C/025/0005
Received 12/31/14
Task ID #4772

Subject: **Response to Rejection for Underground Coal Mine Amendment, Task Id. 4730, Alton Coal Development, LLC, Coal Hollow Mine, Kane County, Utah, C/025/0005**

Subject: **Response to deficiencies for Underground Coal Mine Amendment, Task Id. 4652, Alton Coal Development, LLC, Coal Hollow Mine, Kane County, Utah, C/025/0005**

Note: The location for this cross-section is shown on Figure 2.

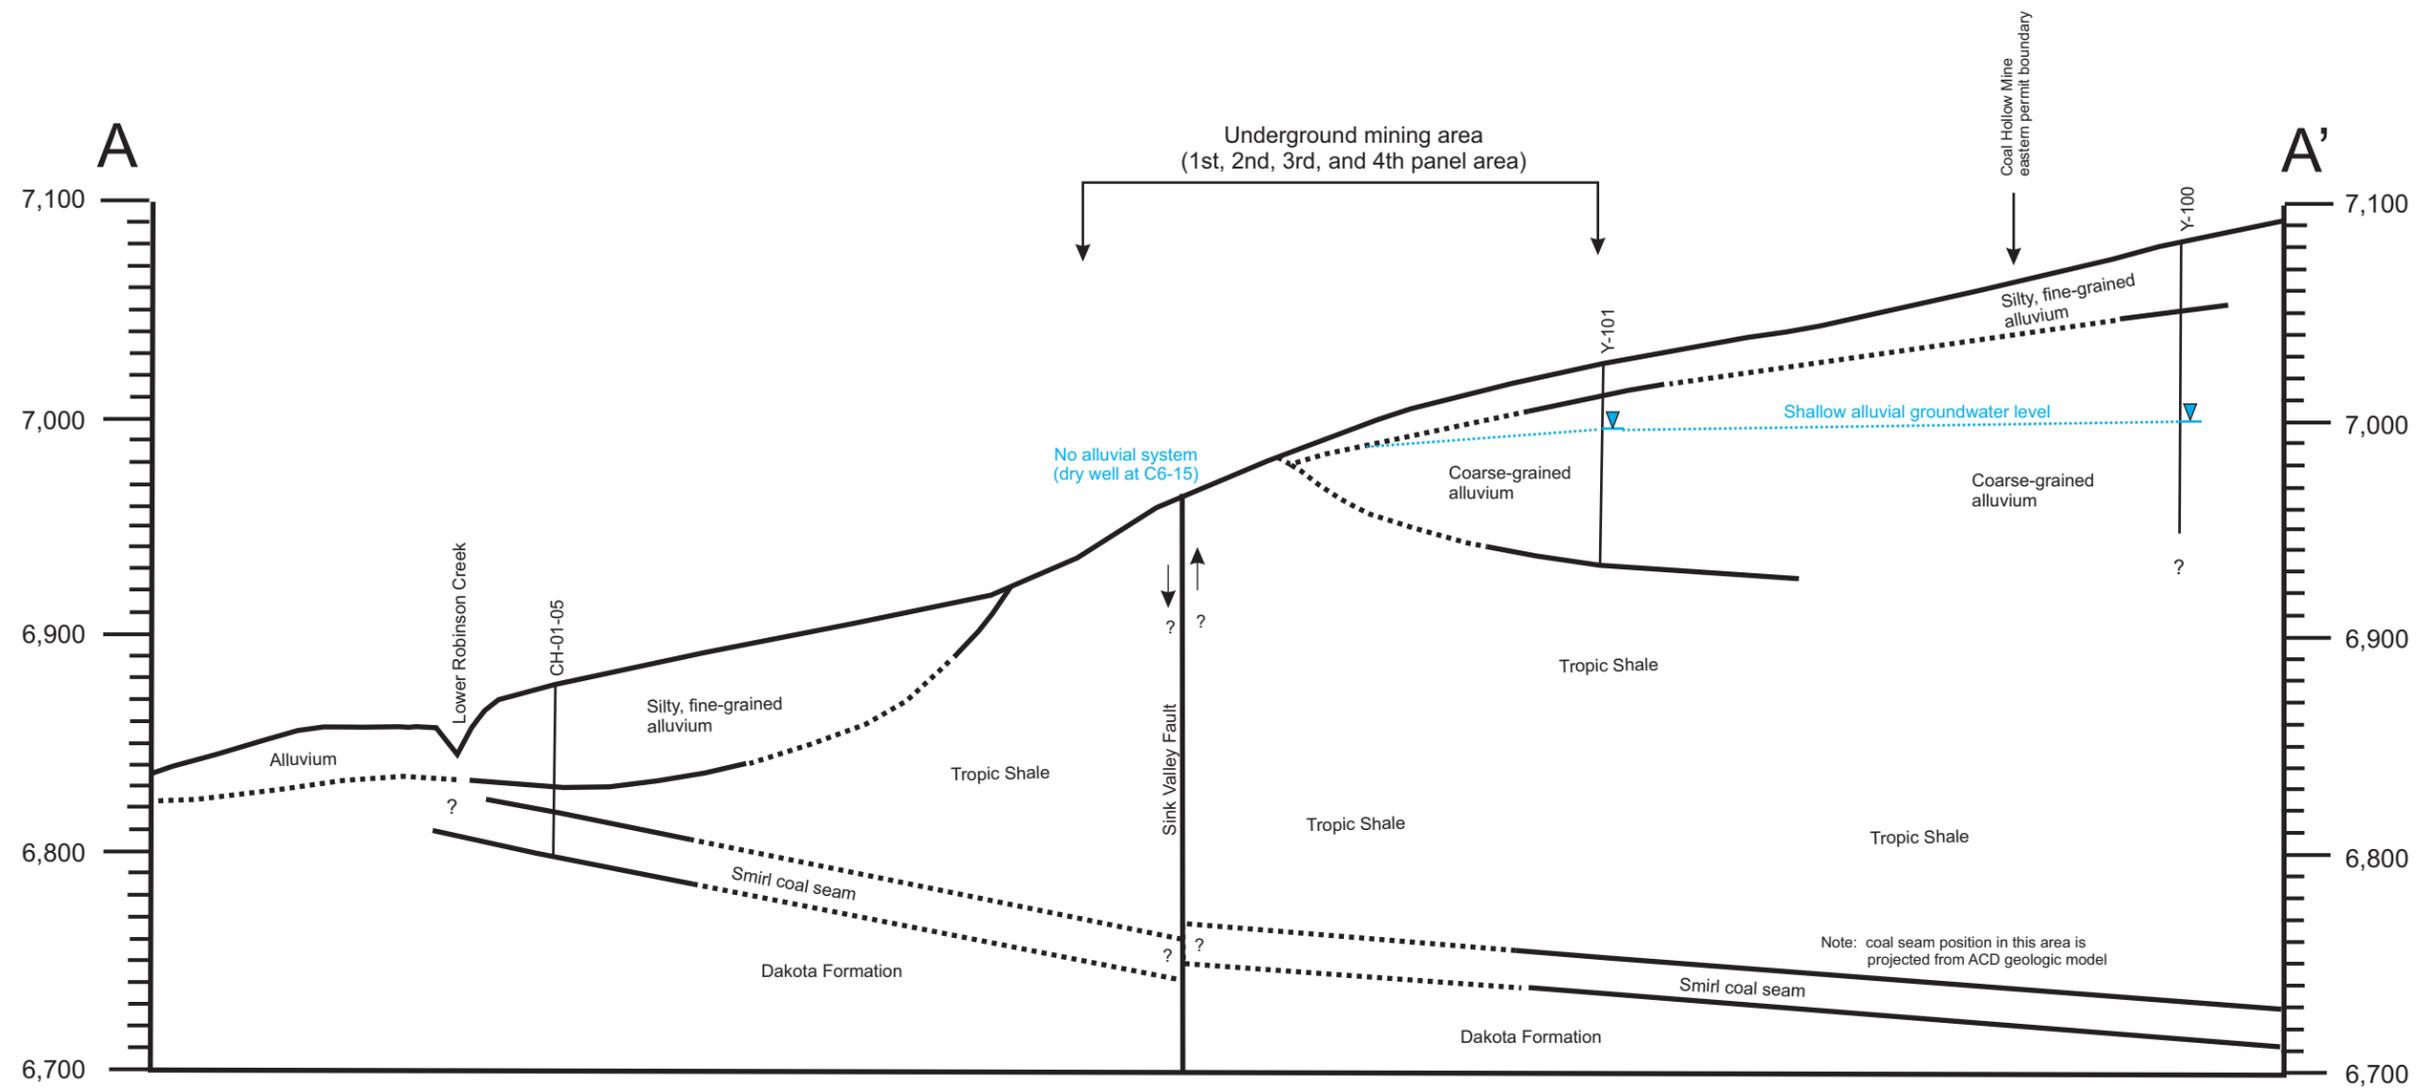
R645-301-622.200, -624.110, -642.210; R645-301-722, -725.100: Need a geologic cross-section between drill holes CH-1-05 and CH-2-05 (extrapolation may be necessary below abandonment depth of well CH-2-05), north of cross-section E-E' in drawing 7-15. Cross-section should include:

Prepared a geologic/hydrogeologic cross-section that includes the requested information. It is presented as Figure 3 in the Petersen Hydrologic PHC for the underground mining. The location for the cross-section A-A' is provide in Figure 2 of the same report (ECP)

DRAWING: 5-3

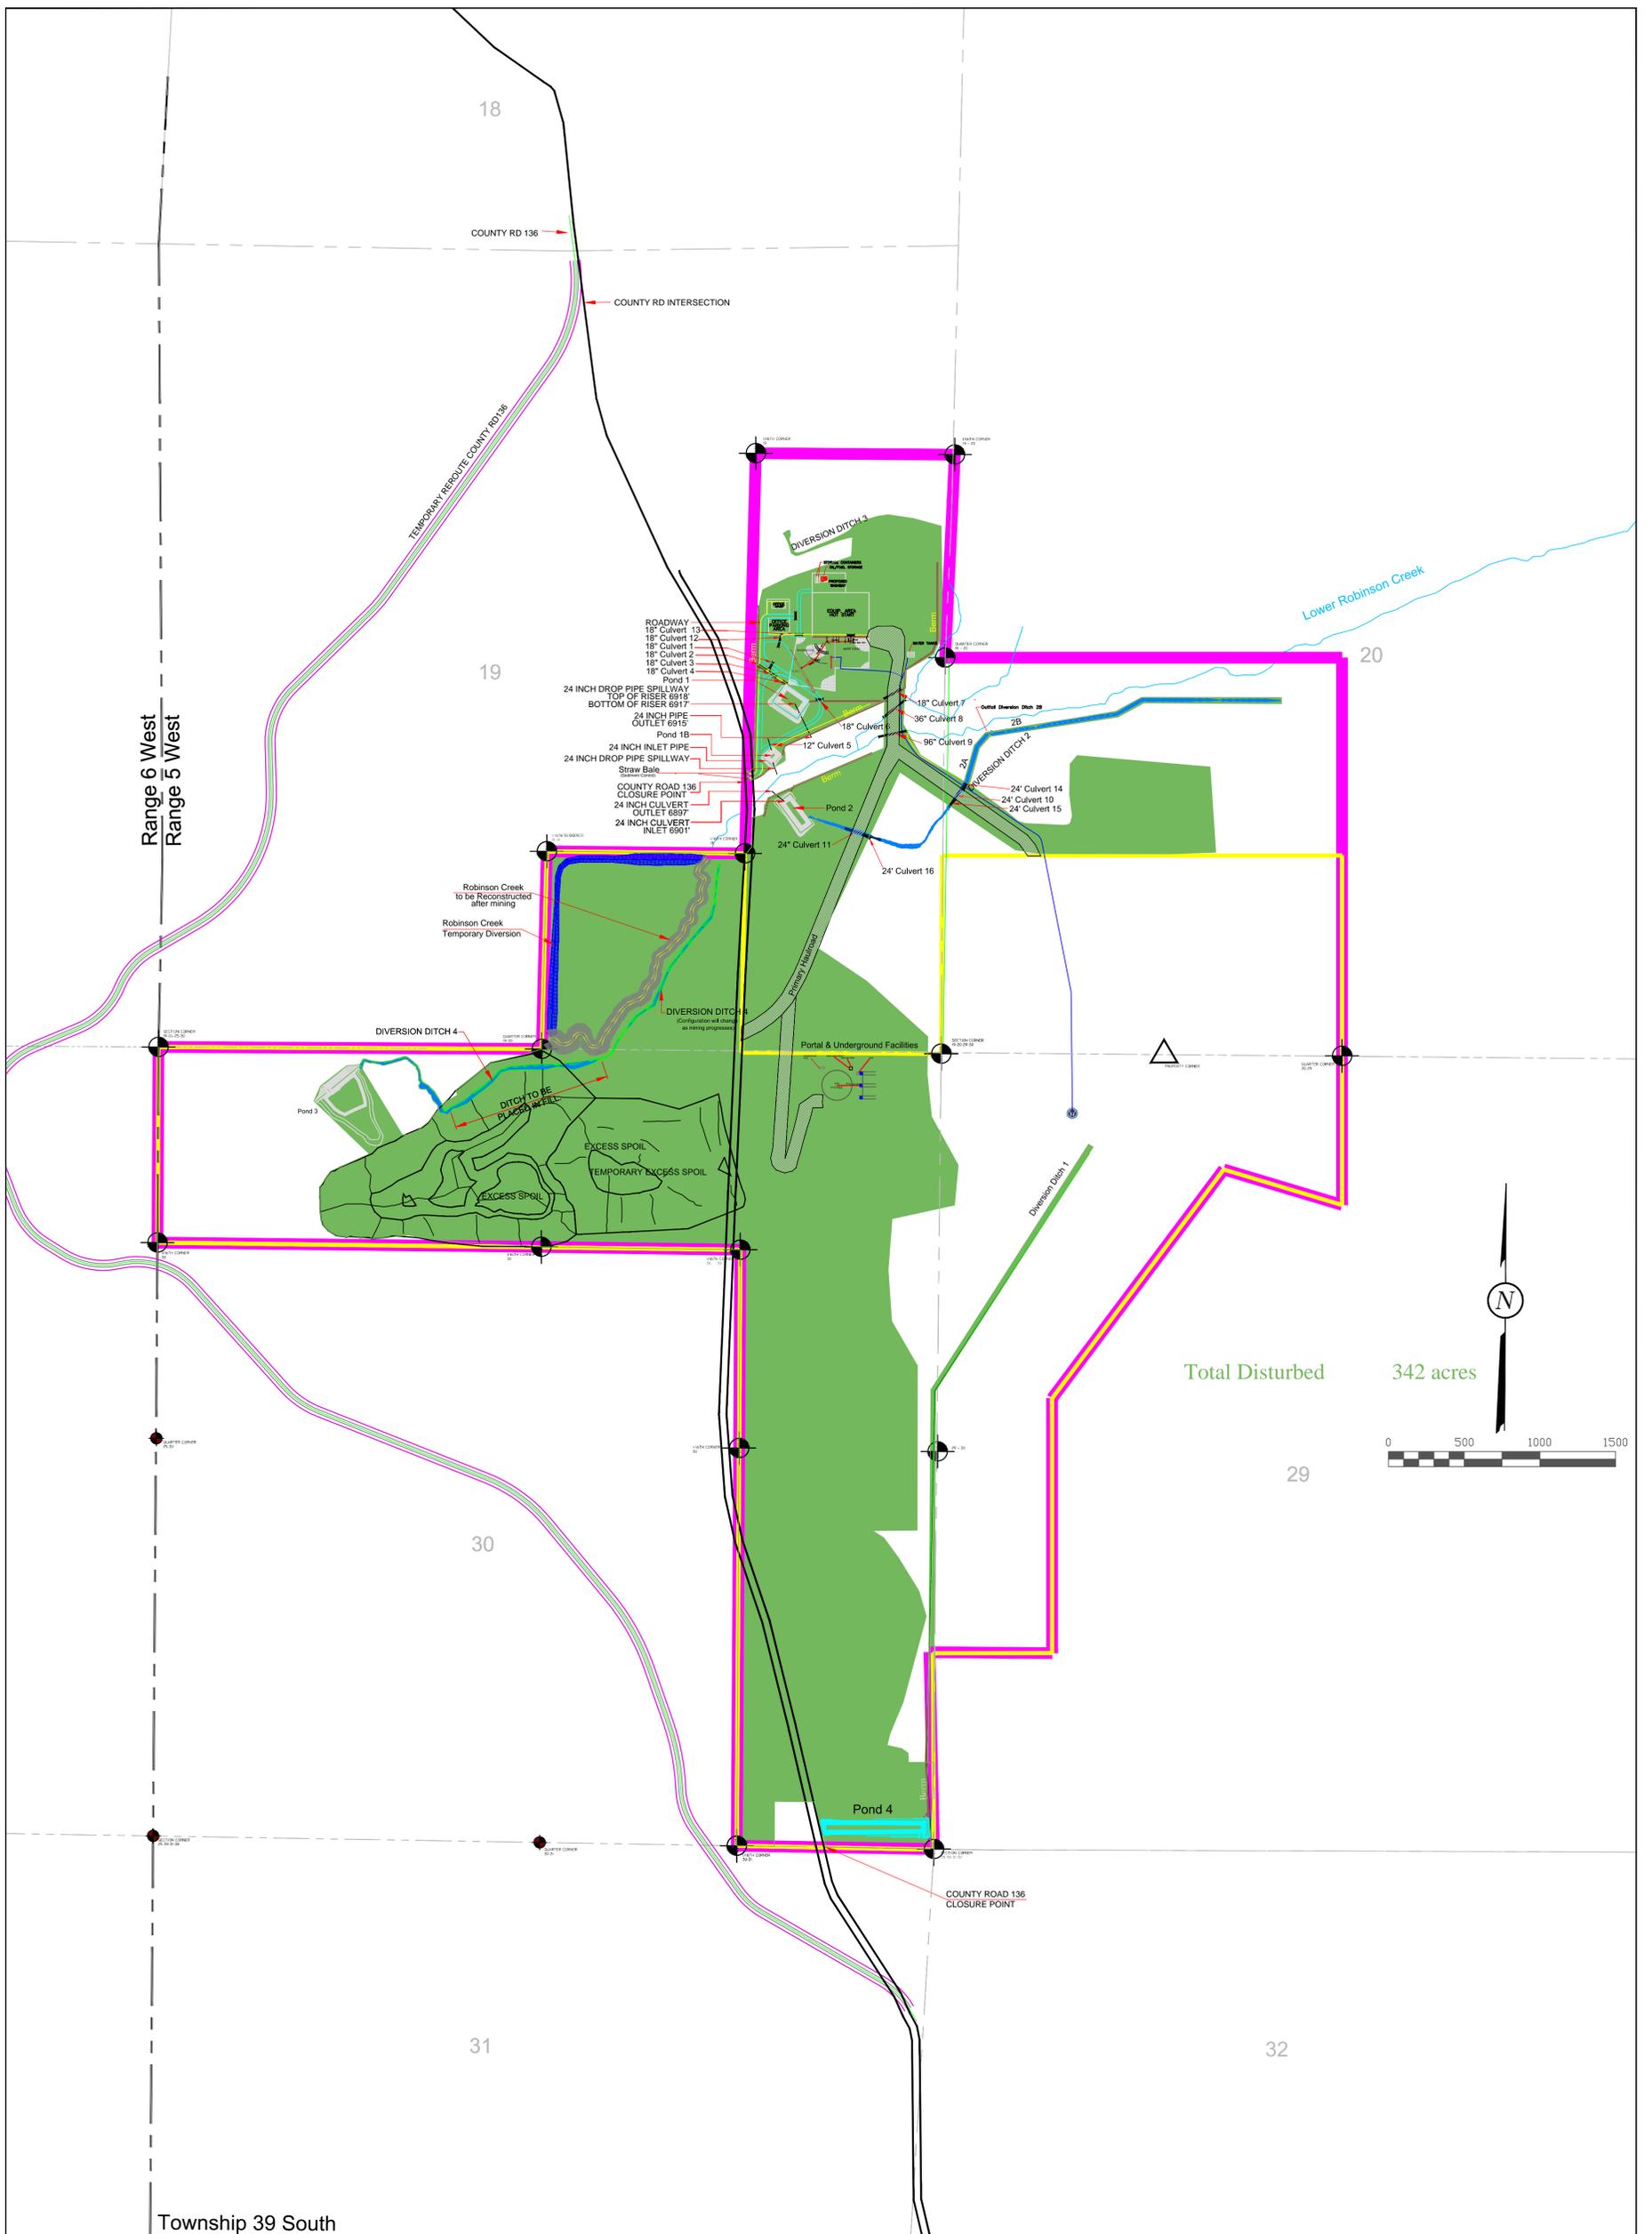
In accordance with R645-3D1-121.200, for clarification, on Drawing 5-3 the area currently show just as the portals should be relabeled ""Portals and Underground Facilities/ Structures Area"" because this area calls out the portals and numerous other facilities/structures associated with the underground operations such as a the portal access ramp, underground product conveyor belt, radial stacker belt, ventilation fan, a generator pad, sump pond, and coal stockpile.

Drawing 5-3 has been relabeled.

DRAWING: 5-30

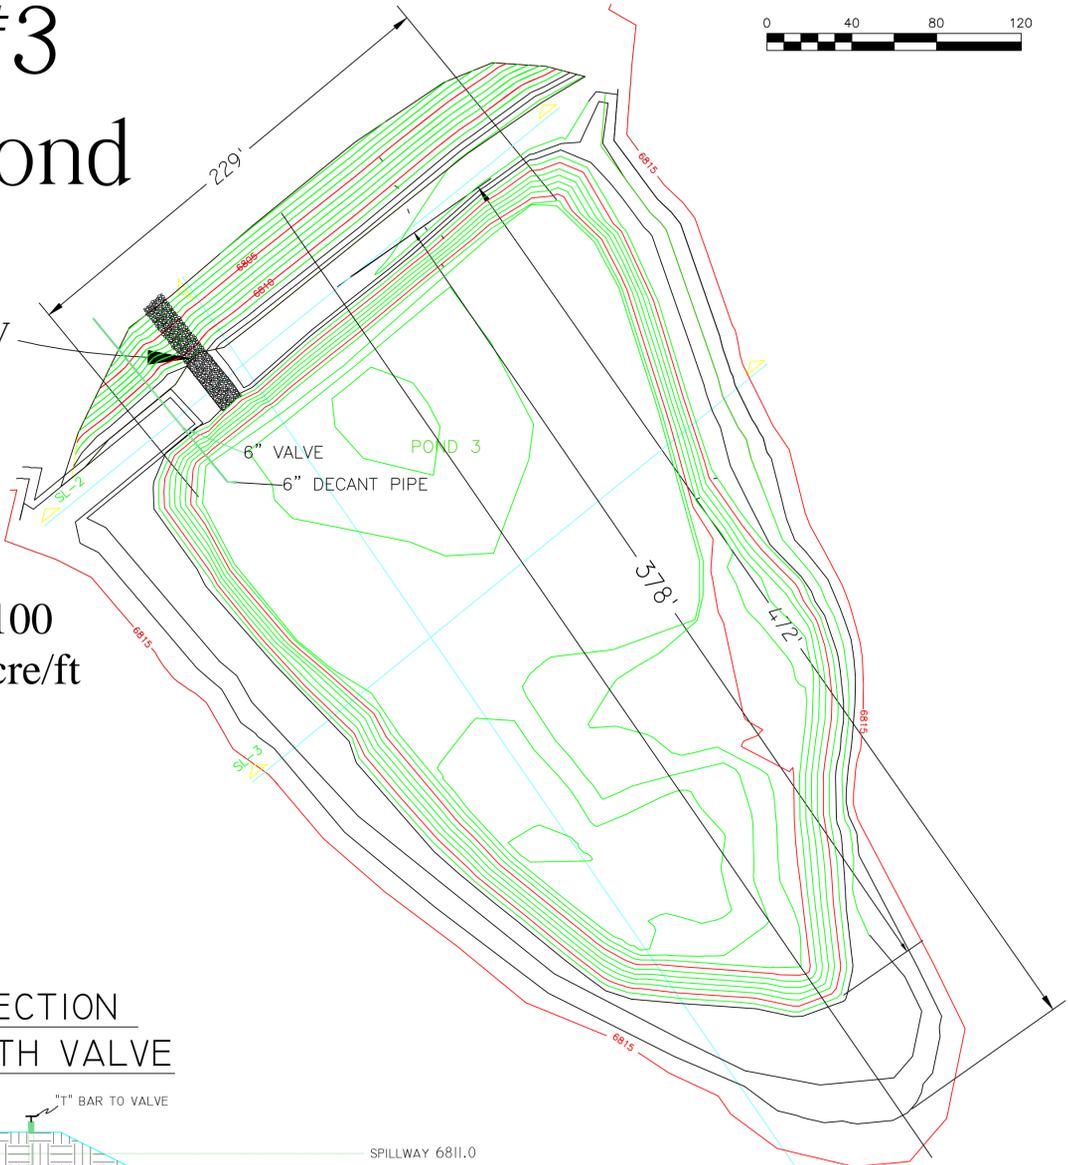
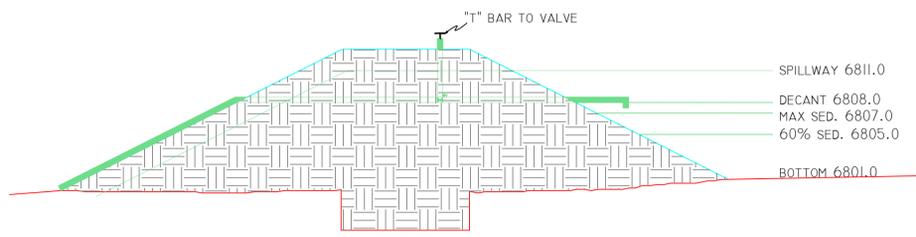
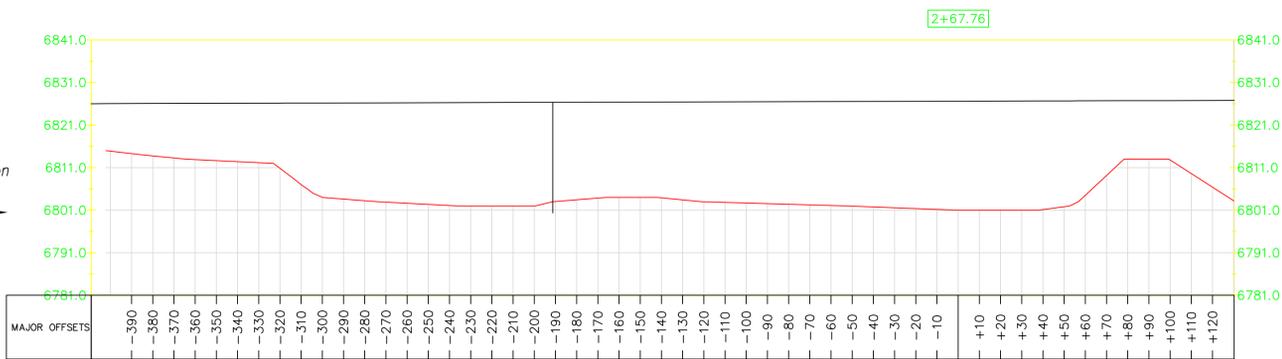
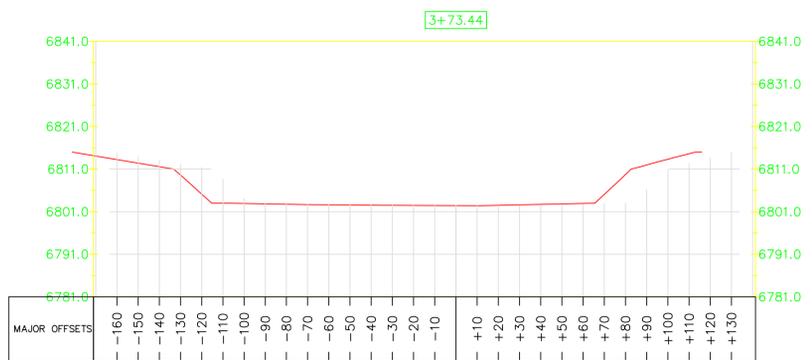
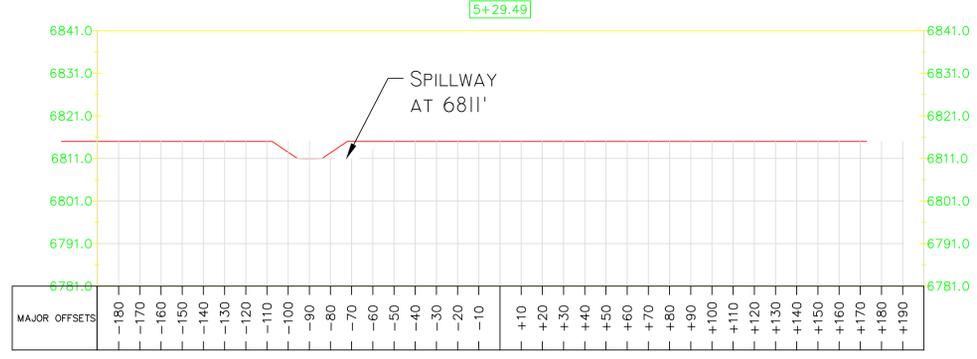
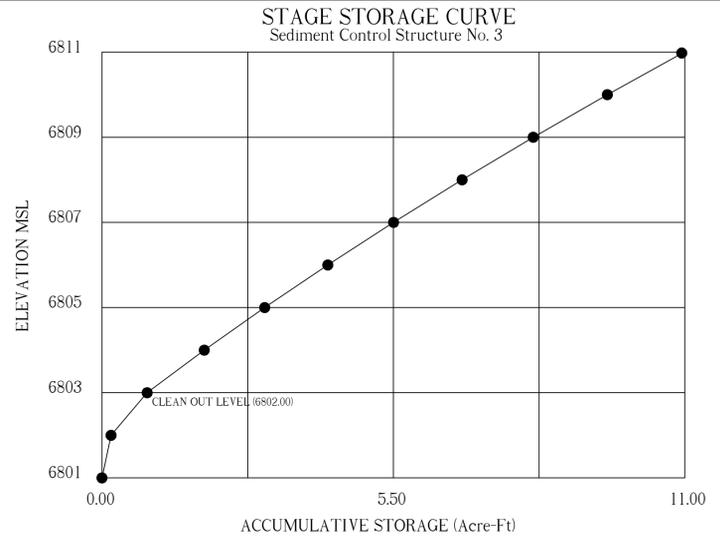
Section 116 has been update as well as drawing 5-3 to show one disturbed area, however, the legal descriptions in Chapter 1 of the MRP are of the property leases not the disturbed areas. Revisions to the legal descriptions of disturbed areas will be revised on Exhibit A of the reclamation agreement. Finally, text and a revision has been added to address the contingency plan to use Sediment Pond 3 with this submittal.
